FOKE • P.O. BOX 584 • GORDON 2072 • TEL (02) 9416 9007
www.foke.org.au **www.facebook.com/ friendsof kuringgai** Est. in 1994
 - Celebrating 30 years of Caring for Ku-ring-gai

Re: State Significant Development SDD-83478456 at 21, 23 & 25 McIntosh Street and 55 Werona Avenue Gordon amended plan - Residential apartment dwelling for approximately 151 including infill affordable housing apartments and 31 TOD affordable housing apartments

Thank you for the opportunity to provide a further submission on the **amended** State Significant Development Application (SSD) proposal at 21, 23 & 25 McIntosh Street and 55 Werona Avenue, Gordon.

Figure 32 Future context – Ku-ring-gai preferred scenario zoning with LMR controls and infill Affordable housing bonus

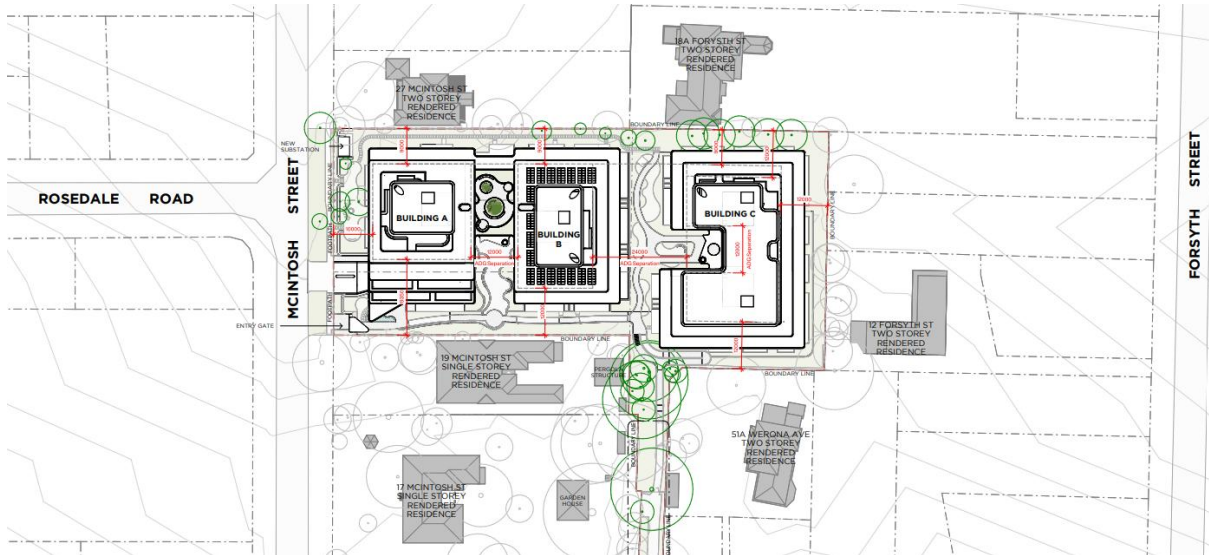
- Comments regarding the visual context of the development in the Response to Submissions are overwhelmingly inaccurate.
- The whole area surrounding the eastern, southern side of the development is zoned R2 with a Height limit of 9.5 metres and FSR of 0.3:1. It is NOT zoned R3 and never has been zoned as

anything other than R2. I contend that this attempt to impose an R3 rating into the figures provided has been inadvertently or intentionally been added.

- Contrary to the comments within the Evolving Context Section 4.4 of the Response to Submissions, it has always been clear what the zoning of this area would be. It has consistently been an R2 zone. The proposed development exceeds the 400metre radius from the Gordon station and hence situates itself incongruously within an R2 zone.
- The comment on page 31 of the Response to Submissions are completely incorrect where it states 'These successive shifts demonstrate that the strategic planning context is not agreed and continues to evolve at a rapid pace. In circumstances where the strategic direction is in flux and no consolidated long-term framework has been finalised, it is difficult for proponents to reliably predict the intended future character for the precinct.' THERE HAS NEVER BEEN ANY ZONING FOR THIS AREA OTHER THAN R2. We are happy to provide the earlier documents if requested.

Figure 3 Biodiversity Values Map shown in purple, site outlined in blue (Source: NSW Planning Portal Spatial Viewer)
From GYDE Response to Submissions and Amendment Report, 12 May 2026, page 11

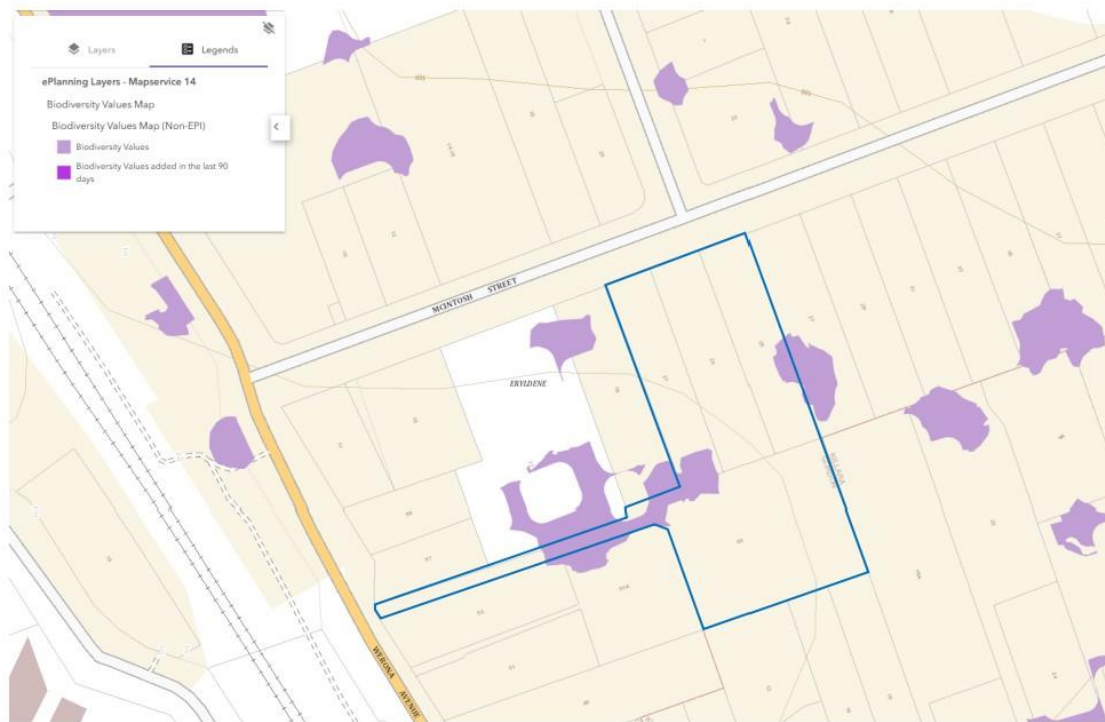
- The above plan indicates the location of the biodiversity values associated with Sydney Turpentine Ironbark Forest (STIF) along the eastern and south-western boundaries and within the development site – yet there is no mitigation for how this Critically Endangered Ecological Community is to be addressed. The map also demonstrates the important of “islands” of

From GYDE Response to Submissions and Amendment Report, 12 May 2026, page 3

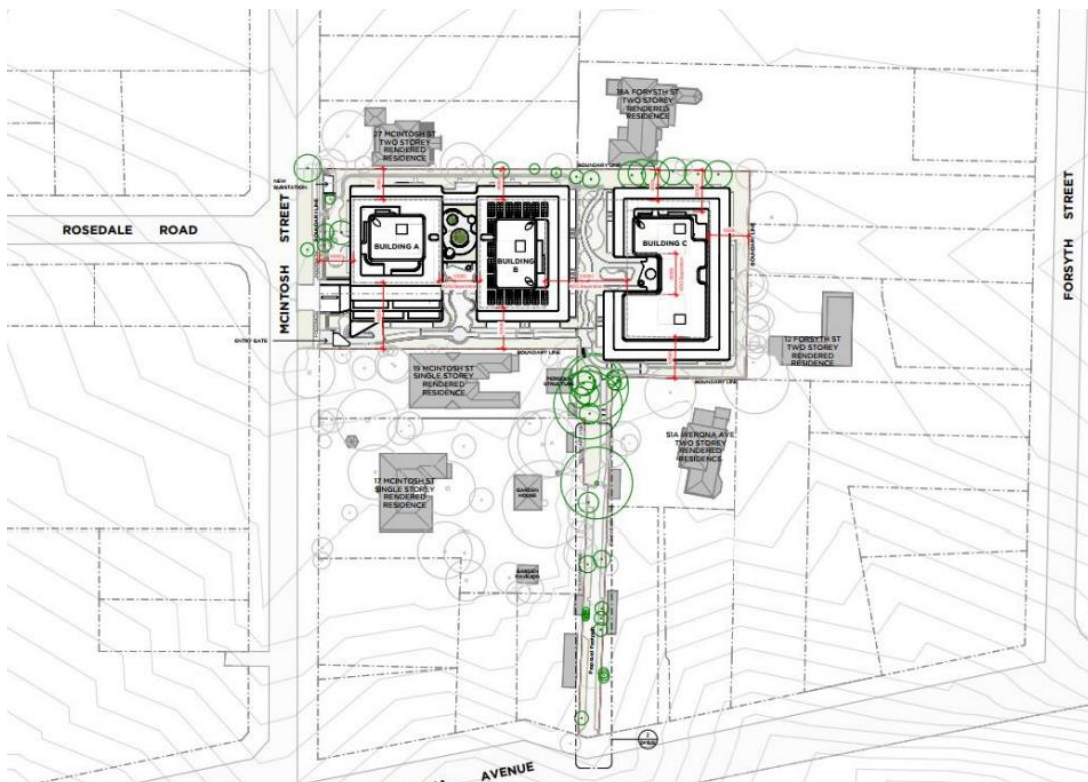
- The site plan in the Biodiversity Development Assessment Report (page 3) illustrates how Buildings A, B and C would create a substantial biodiversity barrier, impeding the movement of wildlife and birds between habitats to the west and Garigal National Park to the east. By fragmenting an important wildlife corridor, the proposal would reduce habitat connectivity and undermine ecological values, highlighting the unsuitability of the development in this location.
